UNITED STATES
DEPARTMENT OF THE INTERIOR
BUREAU OF LAND MANAGEMENT

FORM APPROVED
OMB NO. 1004-0135
Expires: July 31, 2010**SUNDRY NOTICES AND REPORTS ON WELLS**
*Do not use this form for proposals to drill or to re-enter an abandoned well. Use form 3160-3 (APD) for such proposals.***SUBMIT IN TRIPLICATE - Other instructions on reverse side.**

Warren ANW 1
30-015-27748
Yates Petroleum Corporation
February 28, 2012
Conditions of Approval

WELL NAME: Warren ANW #1 **FIELD:** Dagger Draw
LOCATION: 1,980' FSL & 660' FEL of Section 09-19S-25E Eddy Co., NM
GL: 3,528' **ZERO:** 18' **KB:** 3,546'
SPUD DATE: 11/20/93 **COMPLETION DATE:** 1/08/94
COMMENTS: API No.: 30-015-27748

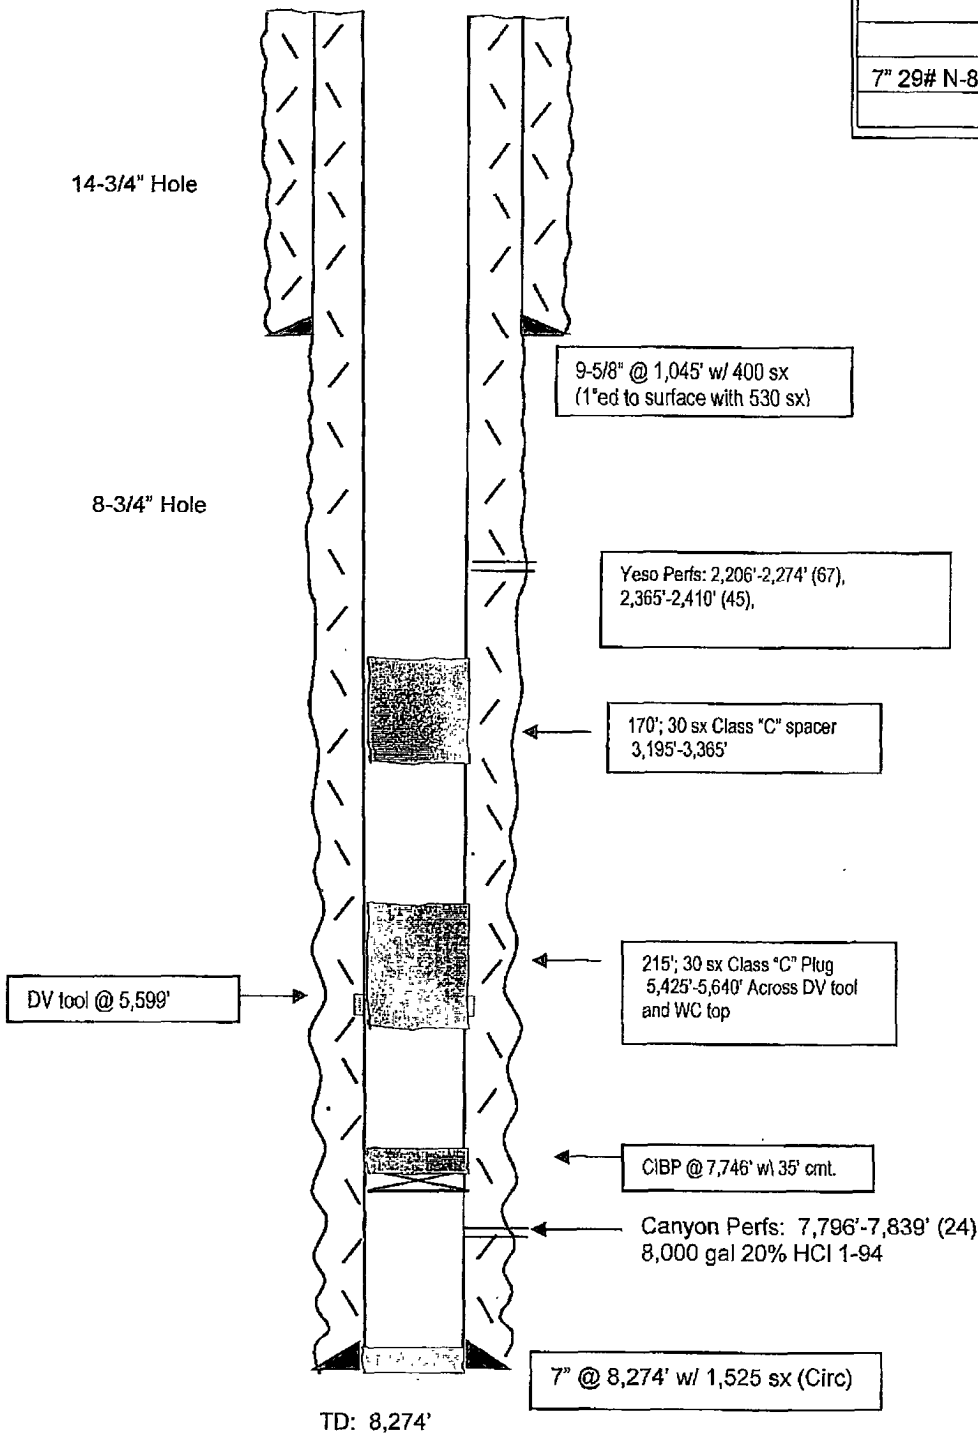
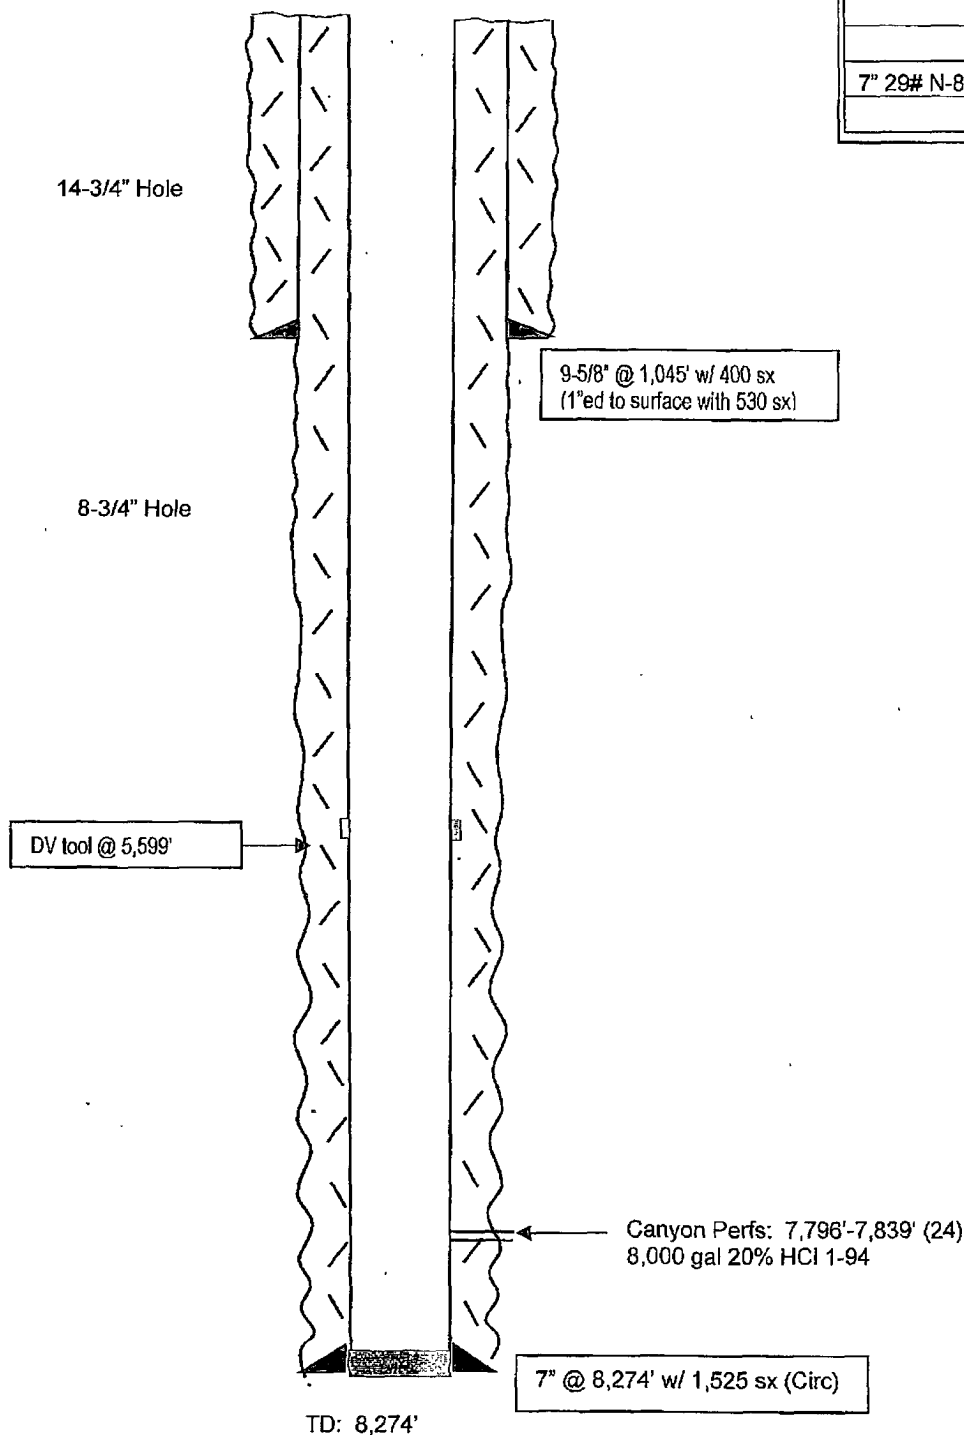
**** BLM REVISED ** BLM REVISED ** BLM REVISED ** BLM REVISED ** BLM REVISED ****

1. **Contact BLM 575-361-2822 a minimum of 24 hours prior to performing operations.**
2. **Plug over the Wolfcamp/DV tool shall start at approximately 5650' (a minimum of 50 feet below DV tool). WOC and tag at 5475' or shallower.**
3. Surface disturbance beyond the originally approved pad must have prior approval.
4. Closed loop system required.
5. 2000 (2M) BOP to be used. All blowout preventer (BOP) and related equipment (BOPE) shall comply with reasonable well control requirements. A two ram system with a blind ram and a pipe ram designed for the size of the work string shall be adequate. Tapered work strings will require an additional pipe ram.
6. Operator to have H2S monitoring equipment on location as H2S has been reported from wells in the area.
7. Completion report and subsequent sundry with well test and wellbore schematic required.
